Quality Audit
Inclusive of Stage 1 Road Safety Audit
for
PROPOSED RESIDENTIAL DEVELOPMENT
AT
THE GRANGE
BREWERY RD, STILLORGAN, DUBLIN 18

Date: August 2019

Reference: RSM/MOB/080719/GRANGE-QA1

Figure 10

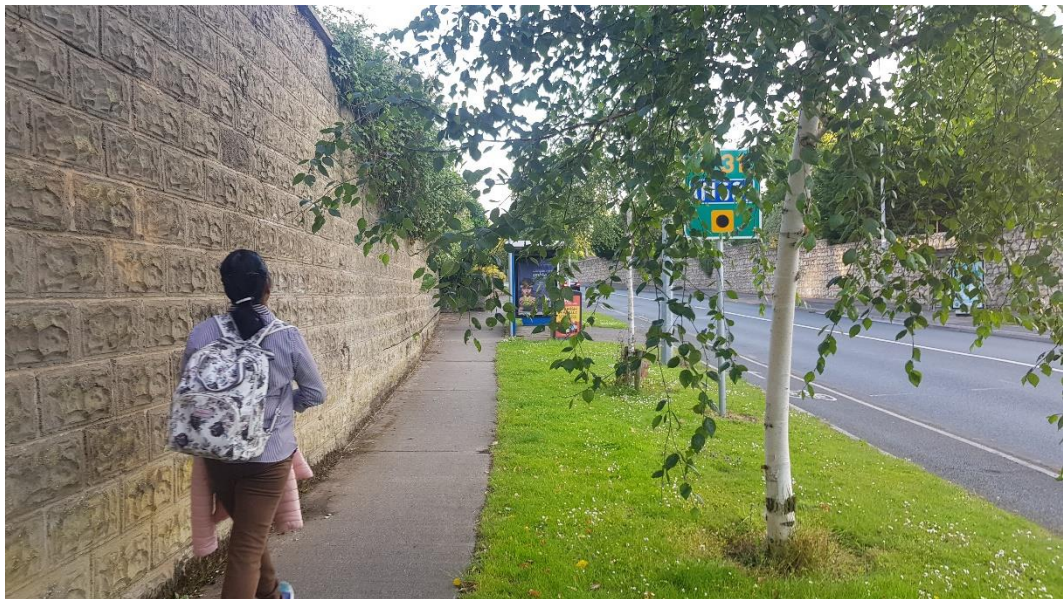
- Trees within the verges on the existing layout present a good separation distance between pedestrians and motorists on the N31, however issues may arise in respect of tree roots damaging pavements and creating trip hazards on the footways surrounding the site, with shedding leaves and shadowing creating potential slippery conditions. A number of the trees on the routes to the site may present overhead hazards, as shown in figure 10. As these are general maintenance issues they will require monitoring by the Local Authority, and are unlikely to cause any significant increase in risks to pedestrians accessing the development site from these directions.

Figure 39: Collision Plot for Road Network Surrounding Site

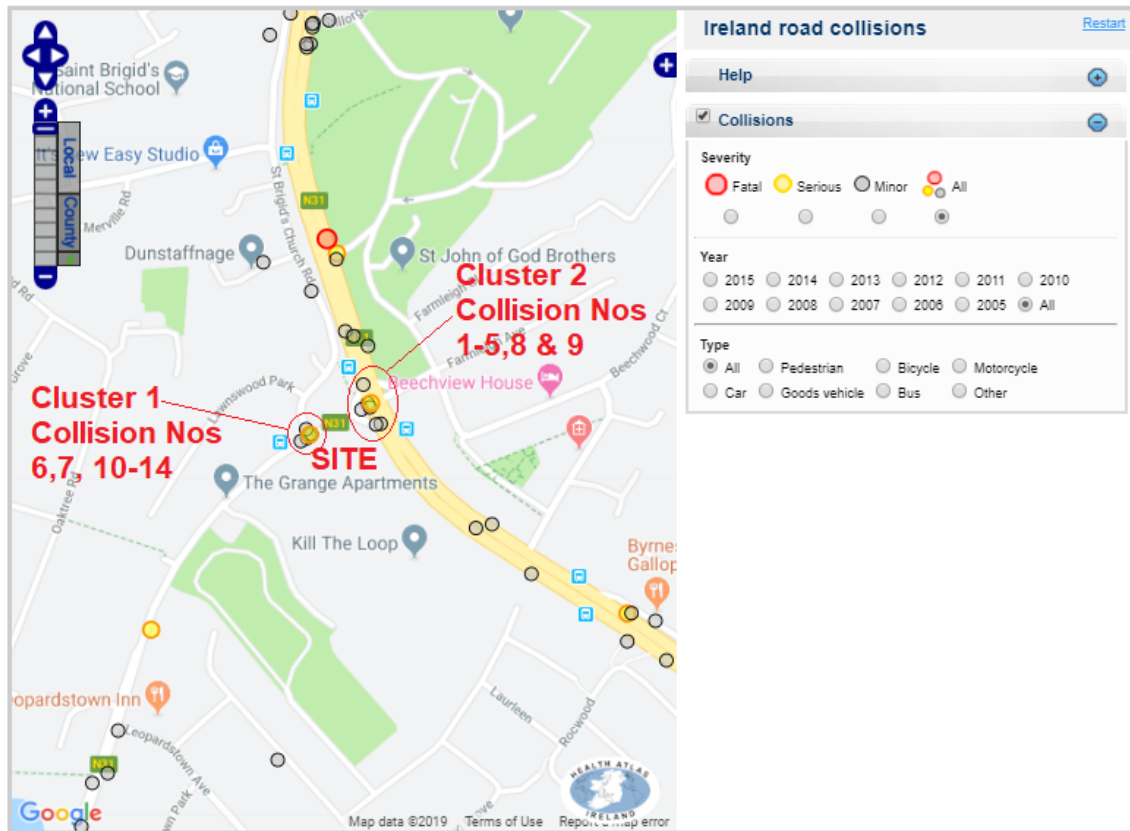
- 3.1.3 No information was provided on any existing collision statistics in the vicinity of the site. A review of the Road Safety Authority online collision database indicates that there are records of a significant number of collisions occurring on the road network immediately adjacent to the site between 2005 and 2015 inclusive, with two collision clusters noted at nearby junctions. The location of these collisions has been shown in Figure 39, with the collision characteristics summarised in Table 1. As mentioned previously in the NMU Audit Section of this QA report, a significant number of collisions occurring at the junction of Brewery Rd/St Brigid's Church Rd involved cyclists (4 collisions occurring at one location over a two year period, one resulting in a serious casualty), which conflicts with the aspirations of an urban area where VRUs should be at the top of the road user hierarchy. The Audit Team considered it likely that a statistically significant increase in collision risk has occurred at this junction in recent times, and further detailed collision investigation into the contributory factors and patterns within these collisions is therefore highly recommended before site development progresses to detailed design stage, particularly since such a high proportion of trips to and from the development are expected to be made by cyclists. The site design should therefore include for remediation and layout improvements where necessary to address the existing collision risks on the approaches to the site.

Additional summary data was obtained for the period 2015 to 2017 inclusive, which shows that 21 material damage only collisions and 7 collisions resulting in a minor casualty were recorded over a 1km (approximately) stretch of the N31 to the northwest of the site, which gives this section of the N31 a collision rate which is above the National Average rate for similar links (urban two lane), in accordance with TII GE-STY-01022, as shown in figure 40. To the northeast of the site, there were 24 material damage only collisions, 3 minor collisions and one serious collision recorded over a 1km (approximately) stretch of the N11, which gives this section of the N11 a collision rate which is below the National Average rate for similar links (urban dual carriageway), in accordance with TII GE-STY-01022.

Figure 49: Landscaping/Sculpture potentially obstructing visibility

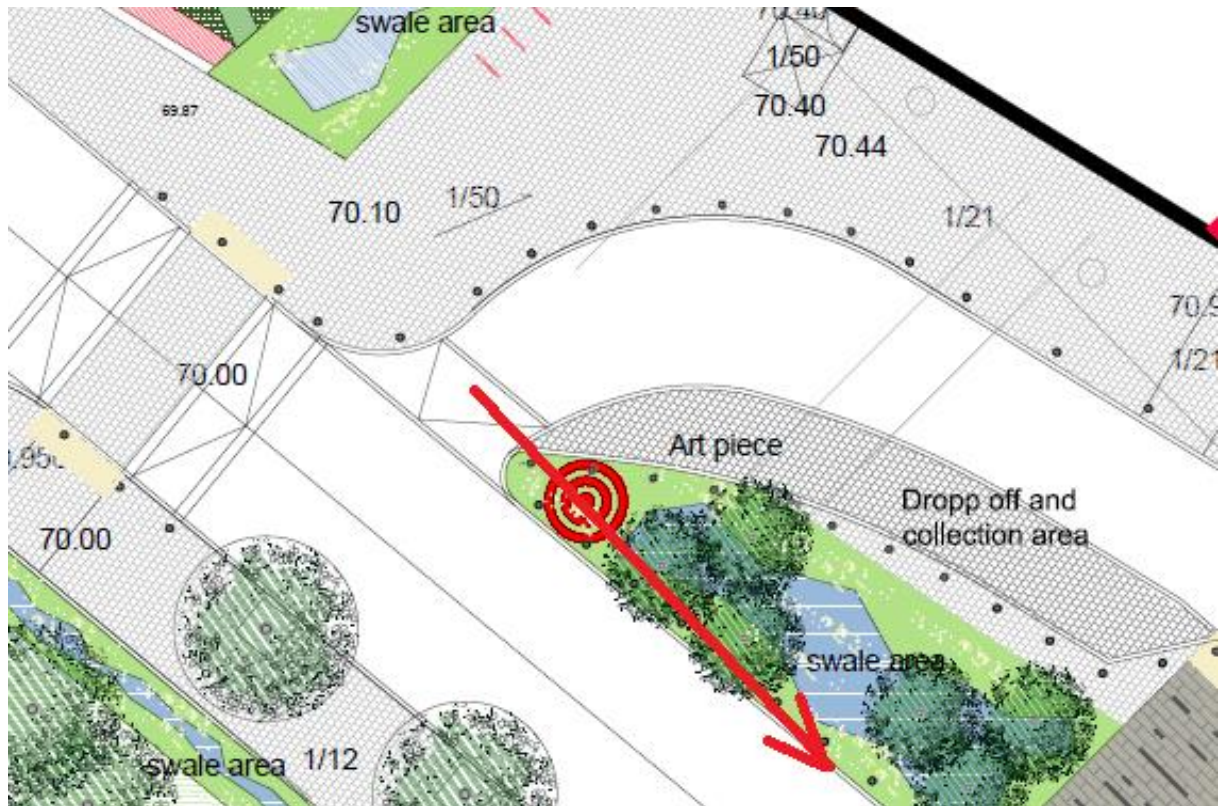
The proposals for boundary treatments surrounding the site are unclear. The landscaping drawings supplied to the Audit Team show provision of trees/landscaping at locations where they may present a hazard to pedestrians and passing traffic, with potential for compromised intervisibility between pedestrians and motorists, as detailed further in section 3.3 of this report. Inappropriately placed landscaping may also obstruct visibility splays at junctions and conflict points. Figure 48 shows an example of a location where landscaping (and a proposed sculpture) may cause an obstruction within the visibility splay at the egress from the set down area, resulting in an increased risk of pulling out type collisions. Figure 49 shows a location where trees will be located too close to the carriageway edge, where the risk of being struck by passing vehicles is increased. Trees at this location are also likely to reduce the effectiveness of street lighting and lead to slippery conditions on the adjacent footways due to fallen leaves. As gradients are relatively steep at this location (5%) cyclists may be particularly vulnerable to the potential slip hazards arising. Tree roots can also potentially

effect pavement stability, creating trip hazards and uneven / broken surfaces, thus increasing safety risks for VRUs / NMUs.

Figure 50: Existing raised crossing on access to the Grange

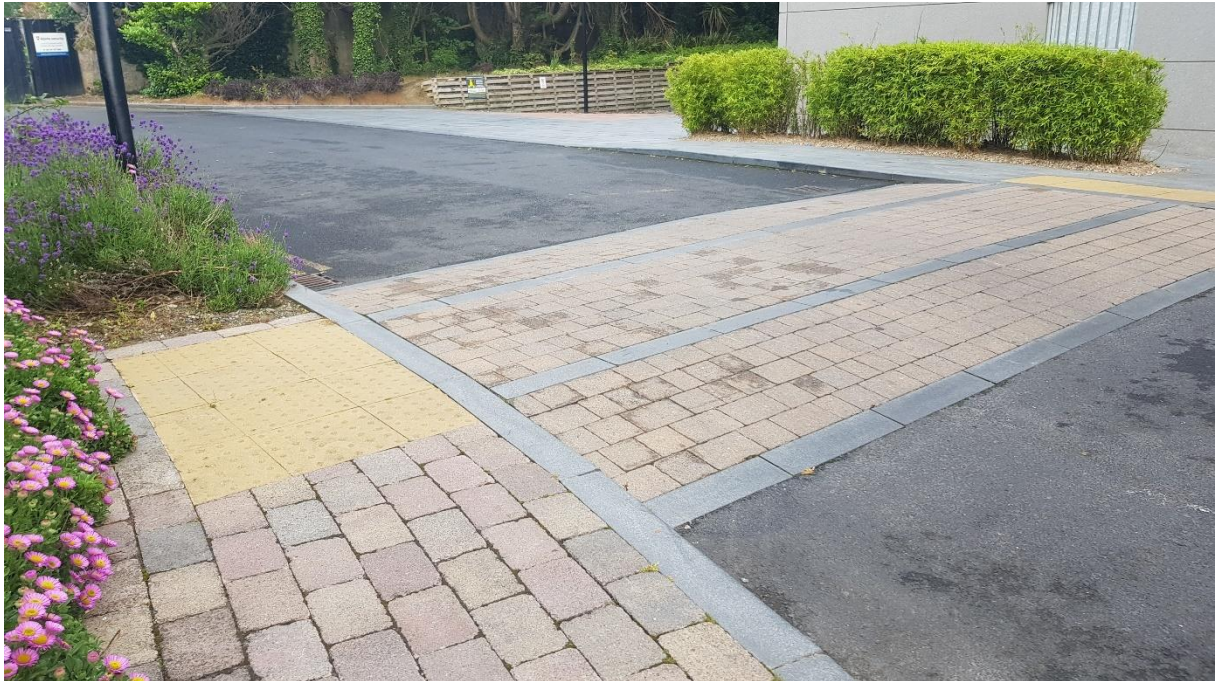
There were no details provided on proposed internal site speed limits, however advisory reduced speed limit signage is advisable throughout the carpark area and access roads, particularly as large proportions of VRUs should be expected to circulate within these areas. It was noted that existing raised crossing points, and proposed raised crossing points on the access roads to and from the site, which are shown in figures 50 and 51, are likely to have a positive impact on vehicle speeds within the site. Provision has been made for speed bumps at the existing basement car park access, as shown in figures 51 and 52. There is no provision for speed control measures on the proposed ramped access to the new basement car park for the development.

Figure 55: Anticipated peak hour traffic volumes at site access

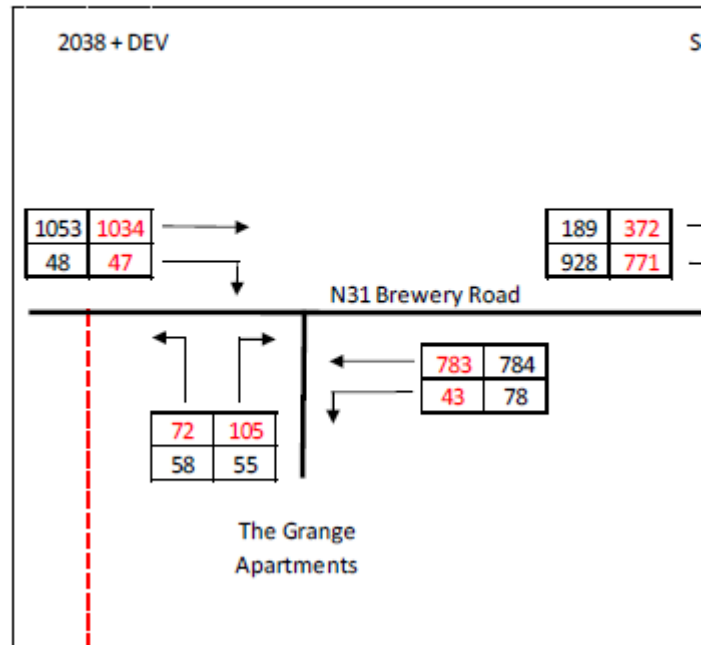
The Traffic and Transportation Assessment (TTA) provided for the site concluded that the reconfigured access junction will operate with sufficient capacity in the future design year. It was noted that there is no provision for a right turn reservoir into the Grange development, and there is insufficient room in the carriageway at present to accommodate waiting vehicles without obstructing through traffic on the N31, as shown in figure 53. Significant difficulties were also observed in terms of gap acceptance when exiting the site, despite the site visit occurring at off peak times. This may increase the risk that motorists will become impatient

For high volumes of traffic on the major road, which would be the case with the N31, priority controlled junctions are generally deemed inappropriate for Annual Average Daily Traffic (AADT) flows in excess of 2,000 vehicles, which would equate to an approximate peak hour flow in the region of 200 vehicles. Figure 55 shows an extract from the TTA provided for the site which shows that anticipated AM peak hour flows will exceed 200 vehicles in the design year.

The Designer should demonstrate that the proposed junction form will safely accommodate all anticipated traffic volumes and speeds. Caution should be exercised when considering capacities at the upper end of each junction type (with reference to the diagram presented in Figure 56) due to the high likelihood of an increase in collision risk and safety concerns. A conservative approach, on safety grounds, is therefore recommended in the determination of the appropriate junction form in the medium to long term.

Figure 58: Proposals for two lane egress from site

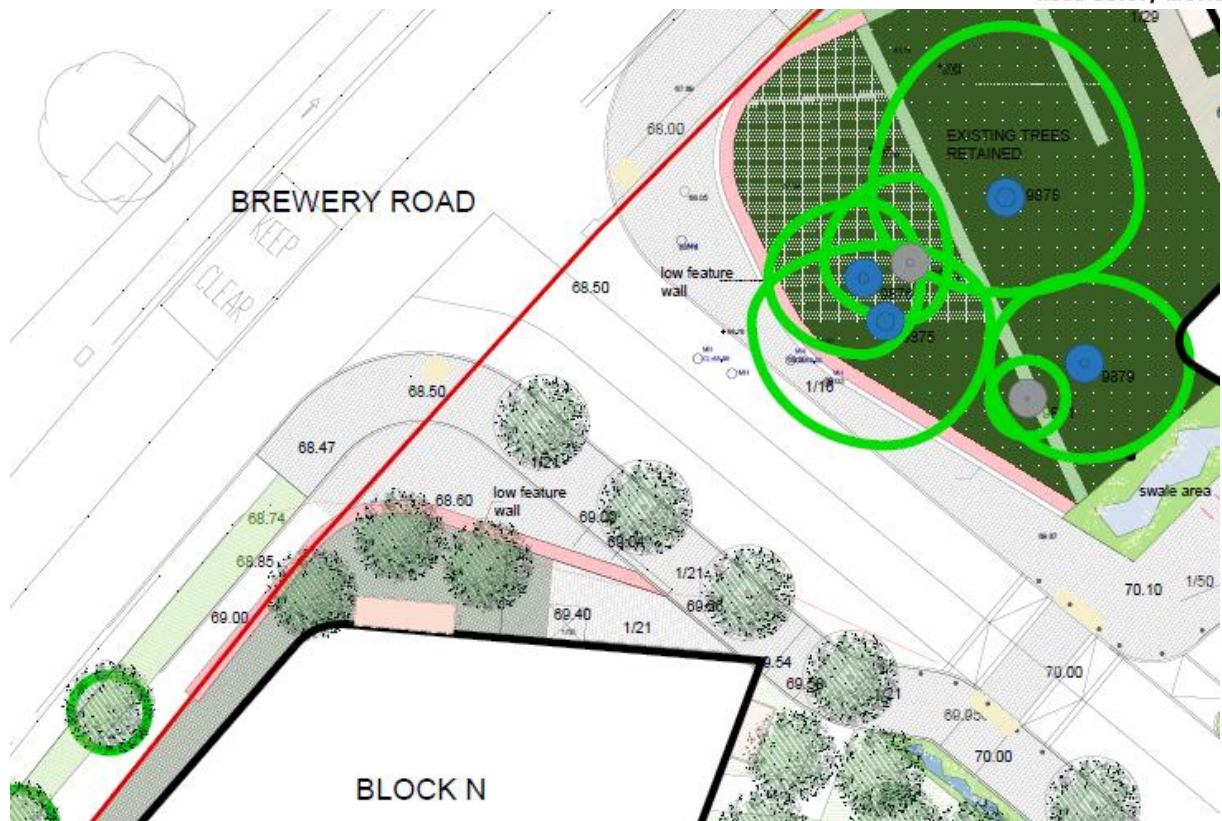
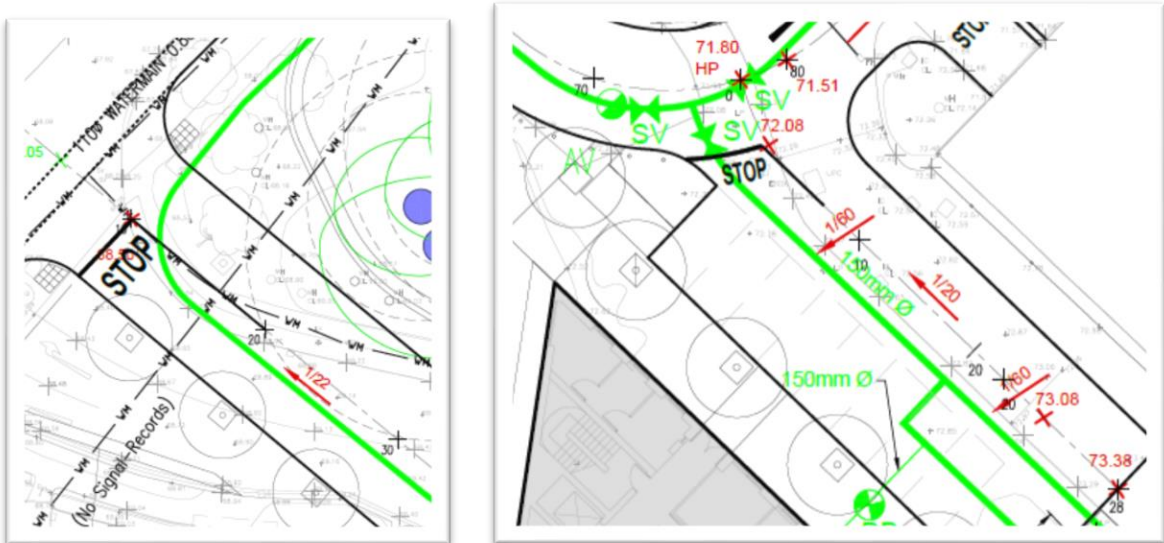
The design appears to include for retention of a two lane egress from the site, with carriageway widening and kerb setback on the nearside, as shown in figure 58. Provision of two lanes of egressing traffic at the stop line on the minor arm of the access junction will increase the number of simultaneously turning traffic streams at the junction, with vehicles queuing in the adjacent lane also potentially reducing visibility to and from traffic approaching from each direction on the N31, as indicated in figures 59 and 60, leading into an increased risk of pulling out type collisions, right angled collisions and rear shunt collisions. Two wheeled vehicles are also more vulnerable on this arrangement, particularly those wishing to turn right, with insufficient space to queue and move alongside larger vehicles in particular.

Visibility should be clear and unobstructed at all times in accordance with traffic speeds. Ideally the egress from the junction should be configured to allow for one lane of egressing traffic only, with sufficient lane width to accommodate cyclists on the carriageway as necessary, due to the limited widths available on the adjacent footway and the lack of safe cycling crossing facilities on the adjacent links at present, or advanced cyclists stop lines. All proposed lane widths at the access junction and throughout the site should be sufficient to accommodate anticipated traffic volumes for all vehicle sizes, inclusive of two-wheeled vehicles.

Figure 63: Drop Off Area

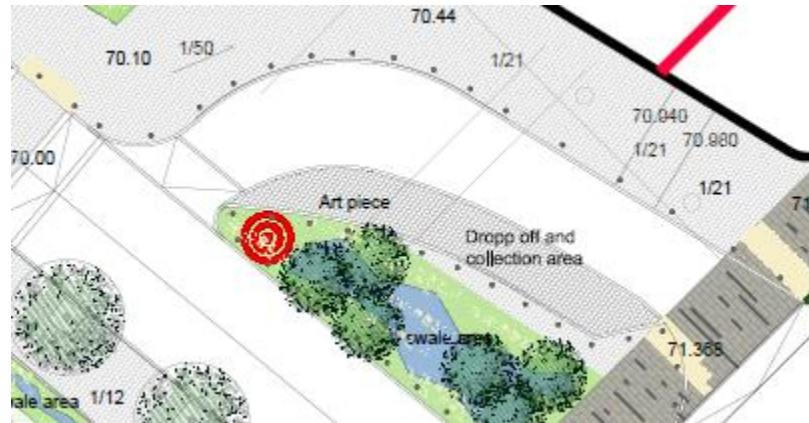
It was noted that there is insufficient space on the footway adjacent to the drop off and collection point, on the passenger side, to accommodate safe waiting or alighting for passengers, and there is insufficient space for disabled passengers and wheelchair users at this location. A number of bollards at this location are likely to present a hazard, and the adjacent swale may also present a hazard. The connectivity to the surrounding network of footways from this point is also unclear.

3.2.2	Yes	Yes. Long and cross sections will be provided at detailed design stage and recommended gradients adopted where possible.		Yes
3.2.3	Yes	Yes. We will remove the proposed bollards and increase the footpath width at this location at detailed design stage. The set down is for cars and small vans only. Turing manoeuvres have been prepared and are shown on drawing 18-093 P-151		Yes

Figure 64: Closely Spaced Junctions with trees compromising intervisibility

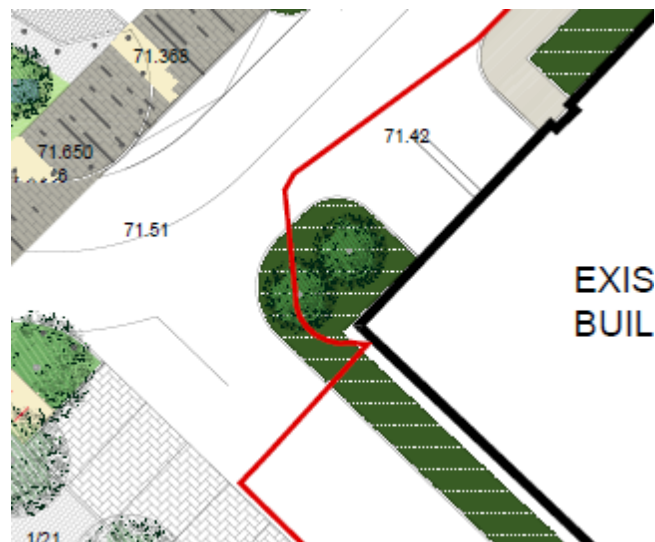
A number of the internal junctions are very closely spaced, as shown in figure 64. Closely spaced junctions can lead to increased conflict due to simultaneous turning manoeuvres occurring in close proximity, and the lack of clarity regarding rights of way and priority. In the case of these junctions, it is acknowledged that traffic movements to and from the creche and set down areas are likely to be low, hence the level of risk is also likely to be low, however the provision of landscaping between the access points may reduce intervisibility and increase risks arising.

All junctions and access points throughout the site should operate safely and independently, taking into account all anticipated peak hour flows. Visibility should be clear and unobstructed at all times, as should rights of way and priority, with landscaping to be removed where necessary to enhance intervisibility.

Figures 65 and 66: Tight radii on access route to site

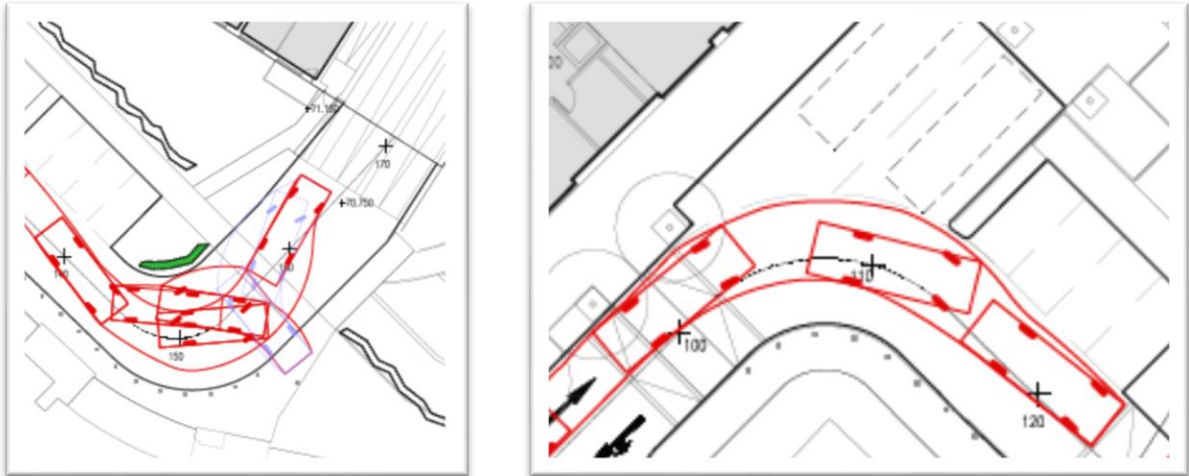
The swept path analysis supplied for the site demonstrates that the proposed geometry is somewhat restrictive for emergency vehicles on the tight turns on the access route to and from the basement car park, as shown in figures 65 and 66. It is unclear if these turns will be possible for more frequent vehicle types, such as SUVs, in the event of a demand for simultaneous two way traffic movements, which is likely, particularly at peak times. Insufficient space for vehicle manoeuvres will lead to an increased risk of side swipe and head on collisions, with turning vehicles also more likely to strike street furniture or encroach into the VRU zones, increasing risks for such road users.

Figure 67: Bollards Adjacent to Carriageway at Crossing Points

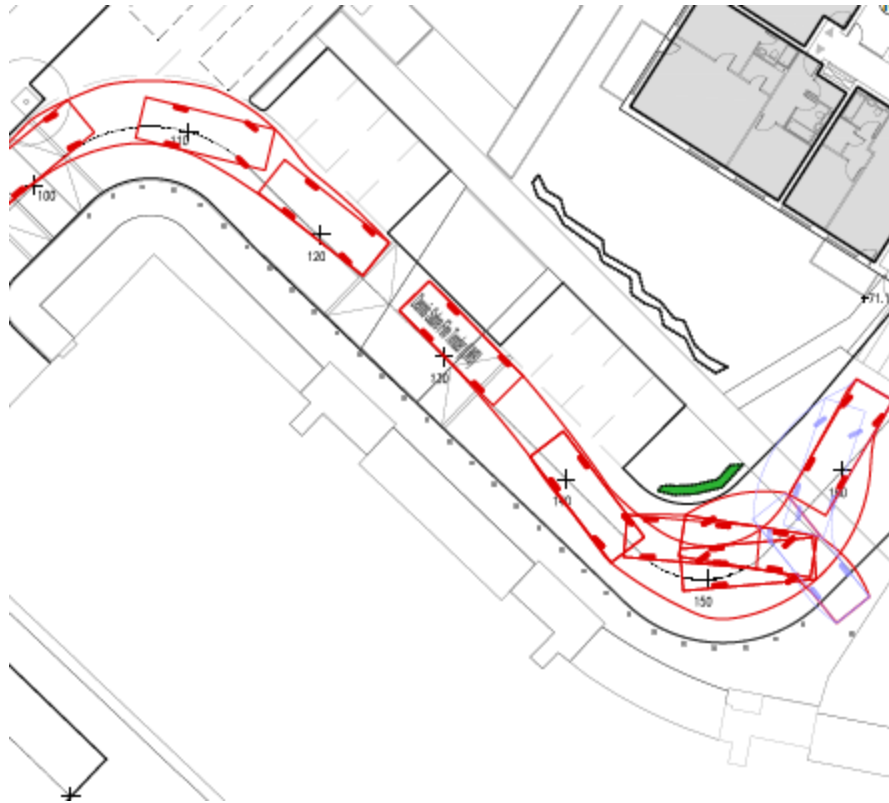
- A number of bollards have been provided at locations which are likely to obstruct pedestrian movement, including at raised ramps. The bollards are also located too close to the carriageway edges where they will present an increased risk of being struck by passing vehicles, particularly on the tight radii on the access road.

Figure 69: Potential Pinch Points on Footways

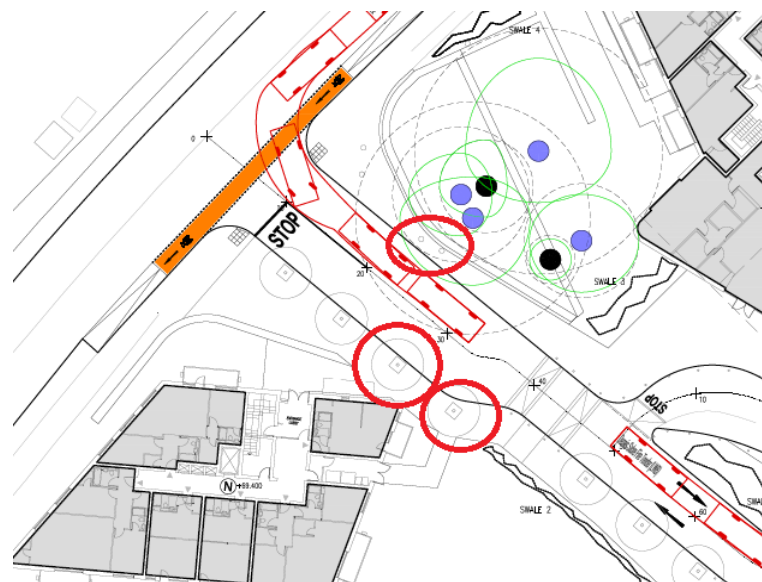
- A number of potential pinch points were noted on footways, including adjacent to proposed landscaping and trees, which are likely to obstruct movement for pedestrians, particularly if spaces are to be shared with cyclists.
